Southern Nuclear Operating Company  
Vogtle Electric Generating Plant Units 3 and 4  
Request for License Amendment and Exemption:  
Fire Protection System Non-Safety Cable Spray Removal (LAR-18-015)

**Request for License Amendment Regarding  
Fire Protection System Non-Safety Cable Spray Removal  
(LAR-18-015)**

**Proposed Changes to Licensing Basis Documents**

**(LAR-18-015)**

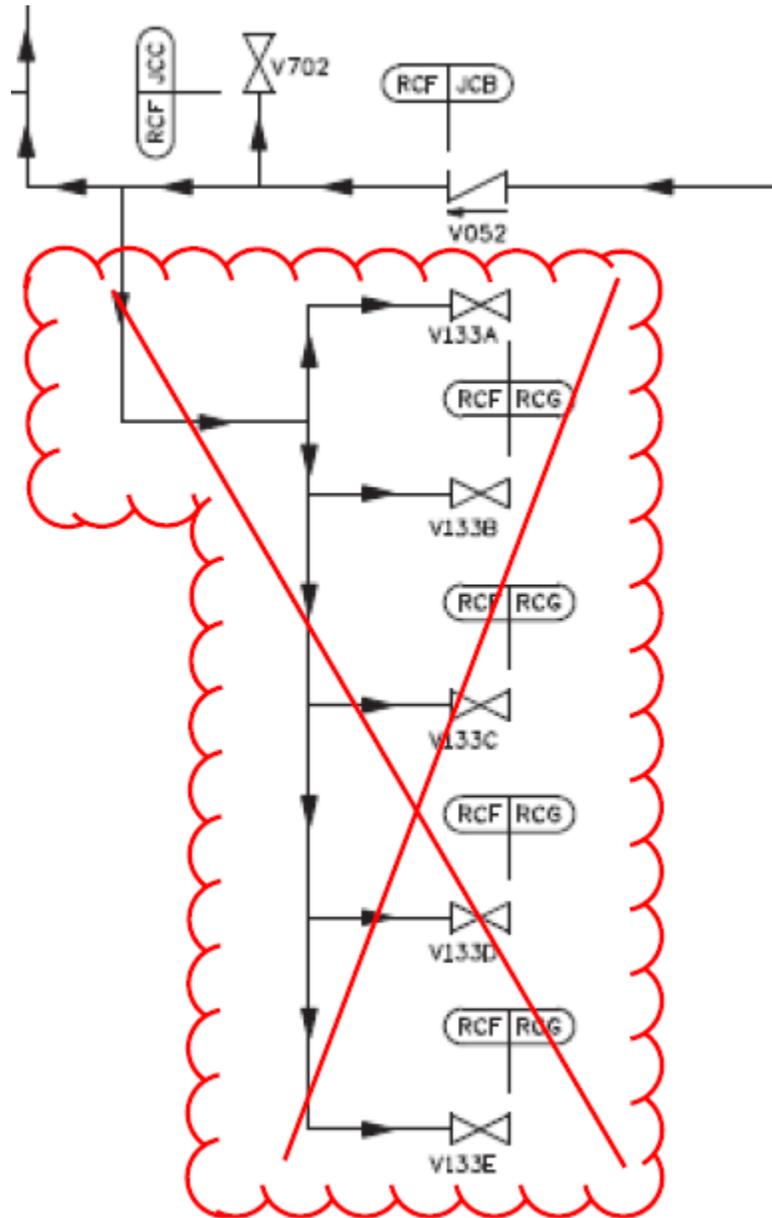
Revise COL Appendix C (and corresponding plant-specific Tier 1) Figure 2.3.4-1, sheet 2 to remove the depiction of containment water spray piping to fire zone 1100 AF 11300B (shown in bubble) as shown below:
